# **Highway 401 Power Dam Bridge and Interchange Study Preliminary Design and Class Environmental Assessment**

Errata to Transportation Environmental Study Report

June 18, 2026

Project/File:  
132800060

Figure 6: Land Use Schedule A4 of the United Counties of Stormont, Dundas and Glengarry Official Plan (2018)

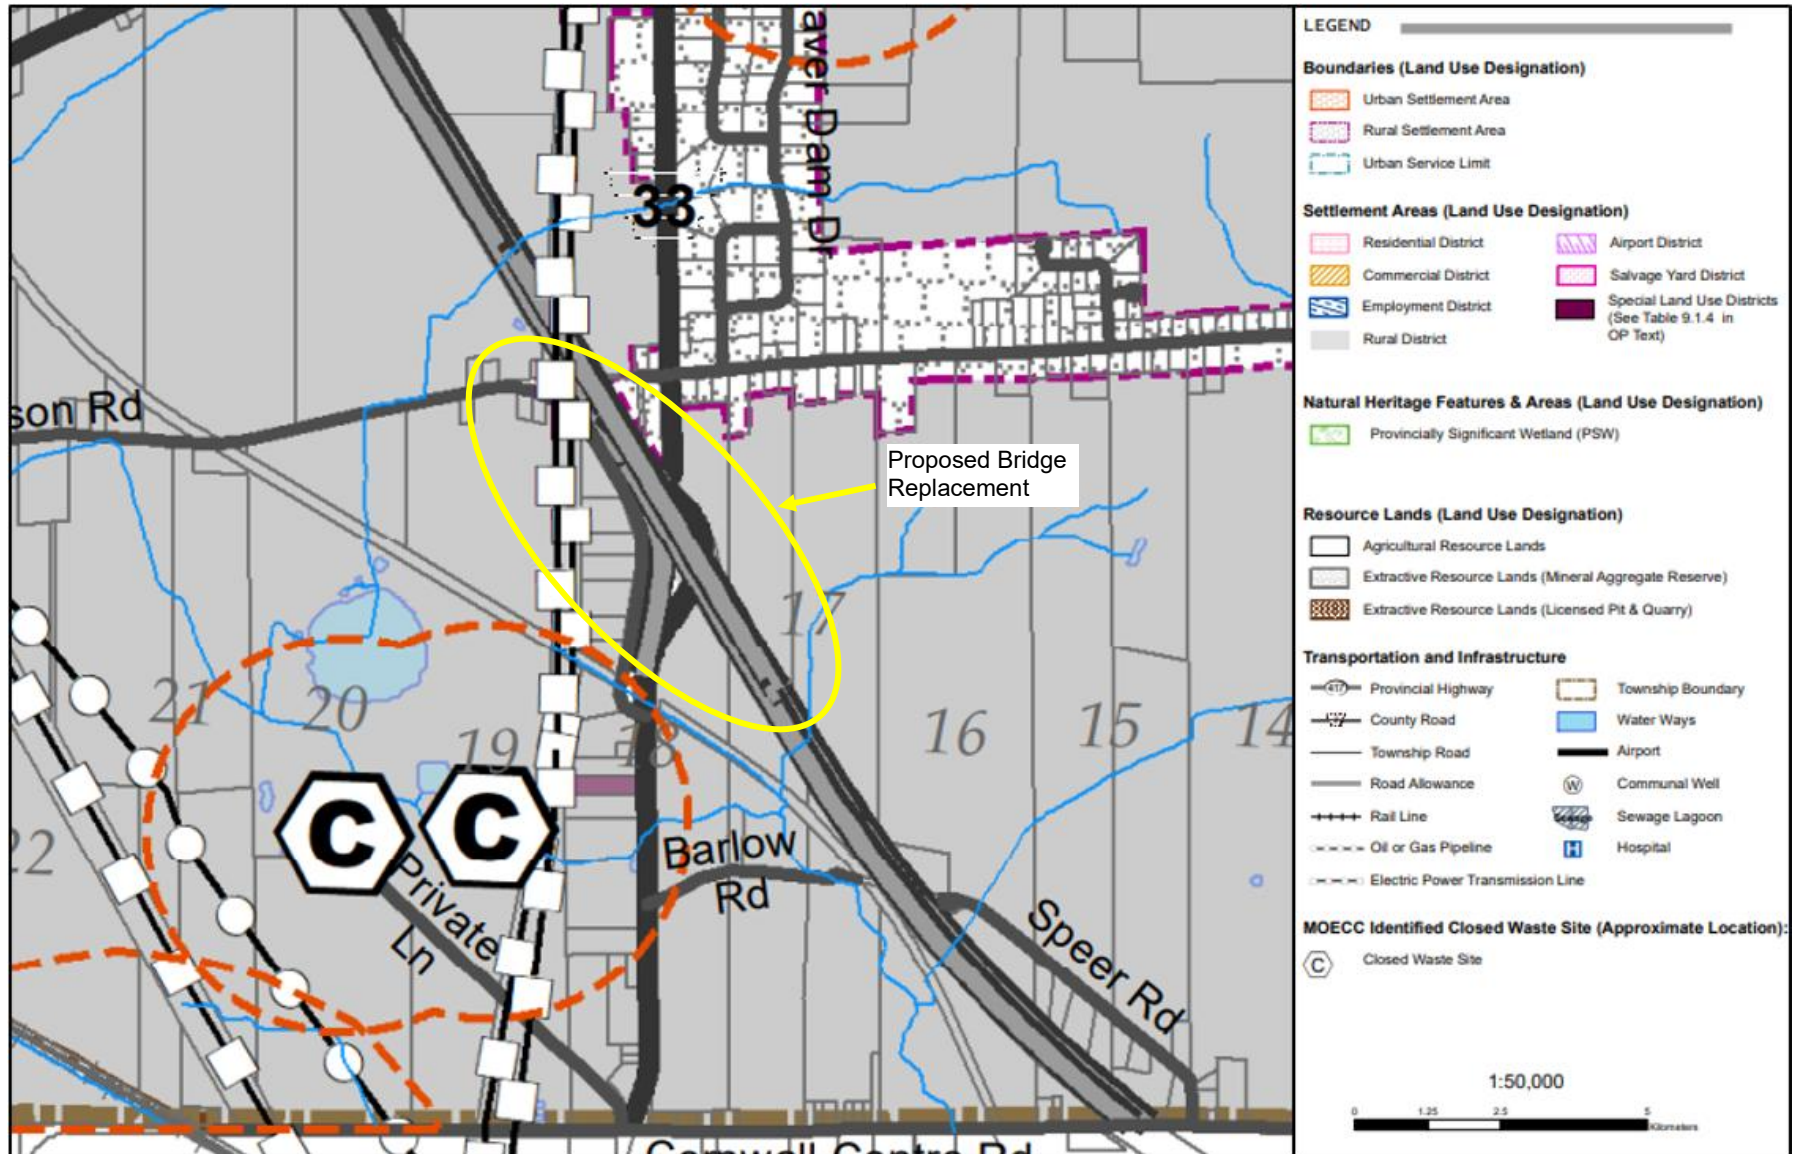
The United Counties of Stormont, Dundas and Glengarry Official Plan (2018) Land Use Schedule A4 sets out land use designations for the Township of South Stormont, see **Figure . It is important to note that United Counties of Stormont, Dundas and Glengarry Official Plan (2018) Land Use Schedule A4 incorrectly identifies a landfill as being located on Lot 19, Concession 4. Based on available information, the landfill is actually located on Lot 20, Concession 3.** Relevant details pertaining to the Official Plan policies and how they affect land uses within the Project Study Area are presented below.

Planned Land Uses Within the Project Study Area

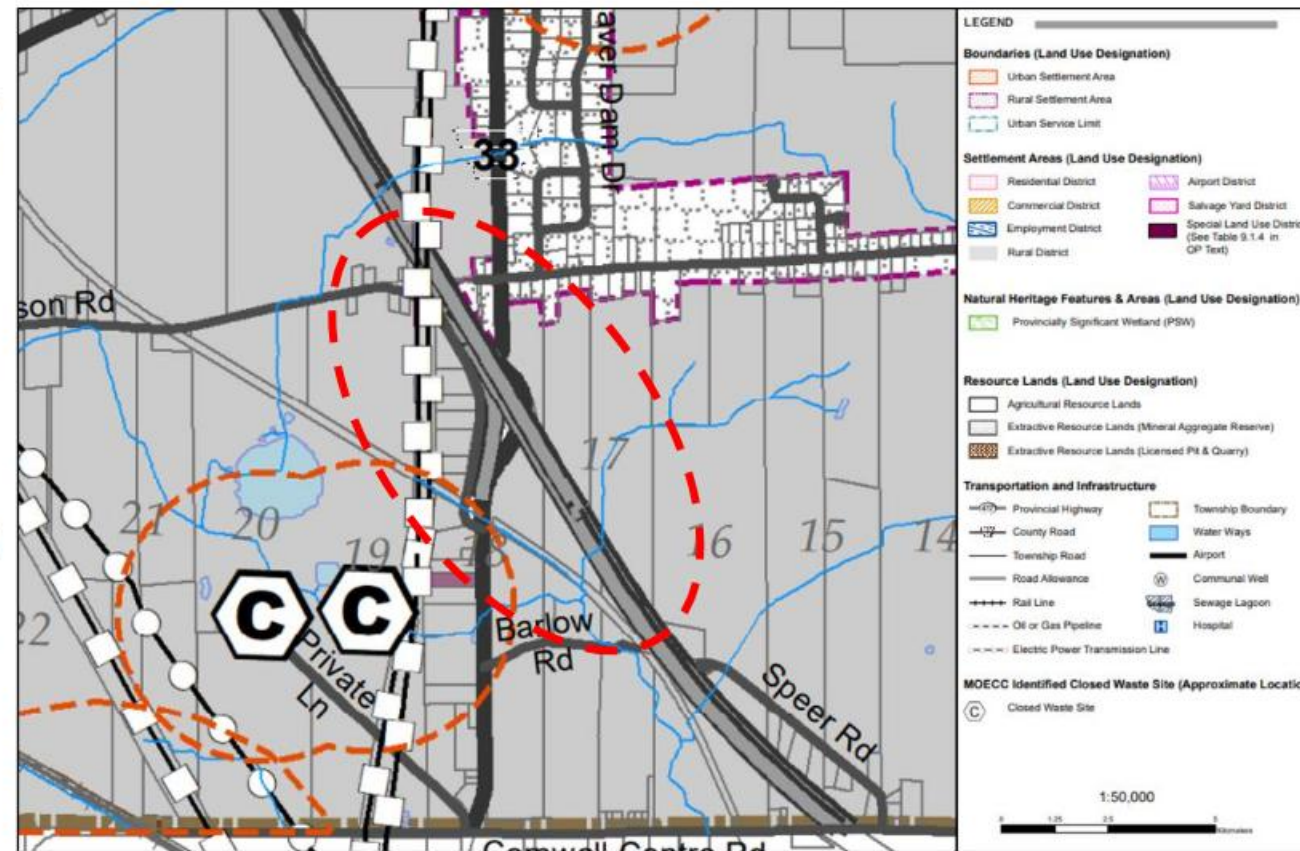
Highway 401 at Power Dam Drive Preliminary Design and Environmental Assessment Study Public Information Centre #1, Slide 21 has been revised below:

It is important to note that the adjacent map incorrectly identifies Historic Landfill Site X1027 on Lot 19, Concession 4. The correct location is Concession 3, Lot 20 within the City of Cornwall.

Utilisations prévues du sol dans la zone d'étude du projet

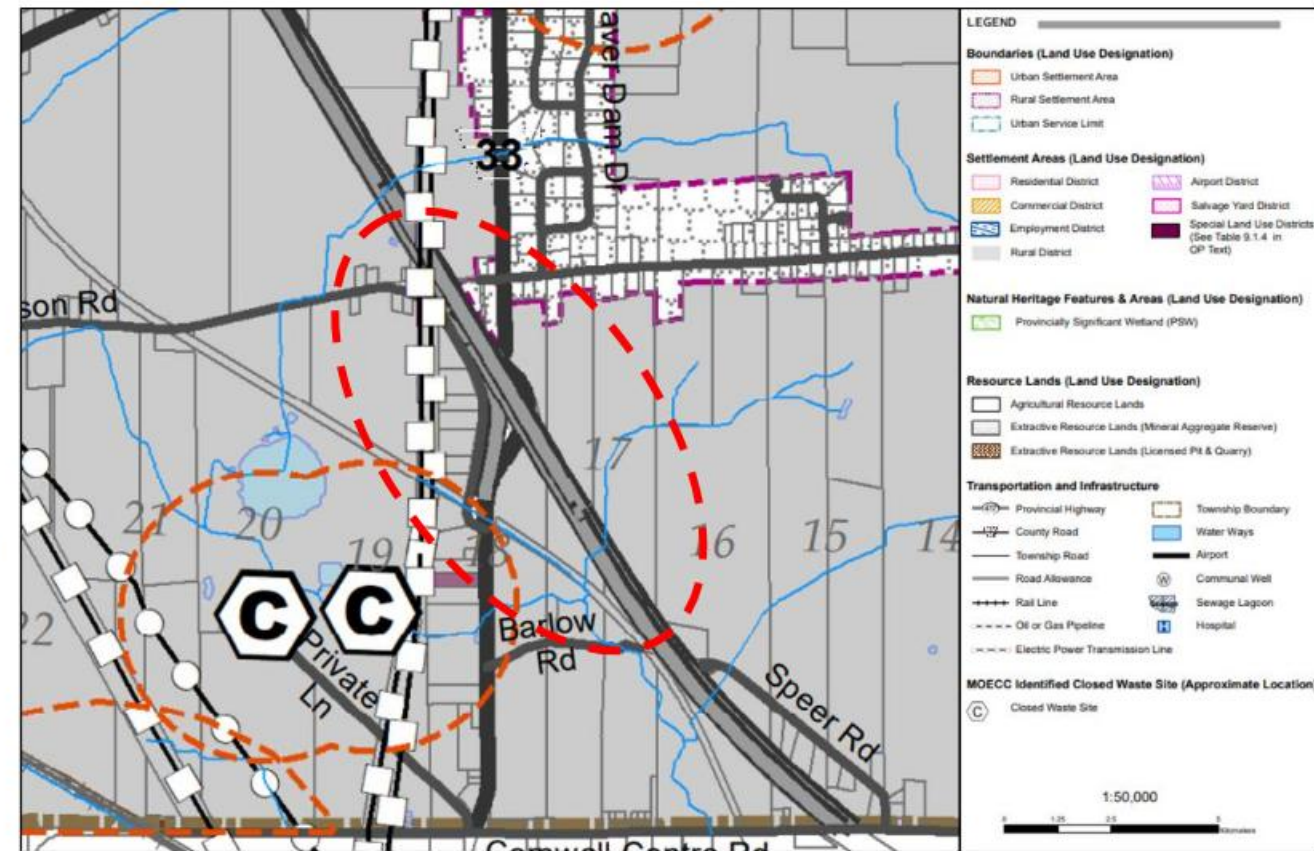
Autoroute 401 à Power Dam Drive – Étude de conception préliminaire et d'évaluation environnementale Séance d'information publique no 1, Slide 21 has been revised below:

Il est important de noter que la carte ci-jointe indique incorrectement le site d'enfouissement historique X1027 comme étant situé au lot 19, concession 4. L'emplacement exact est le lot 20, concession 3, dans la ville de Cornwall.
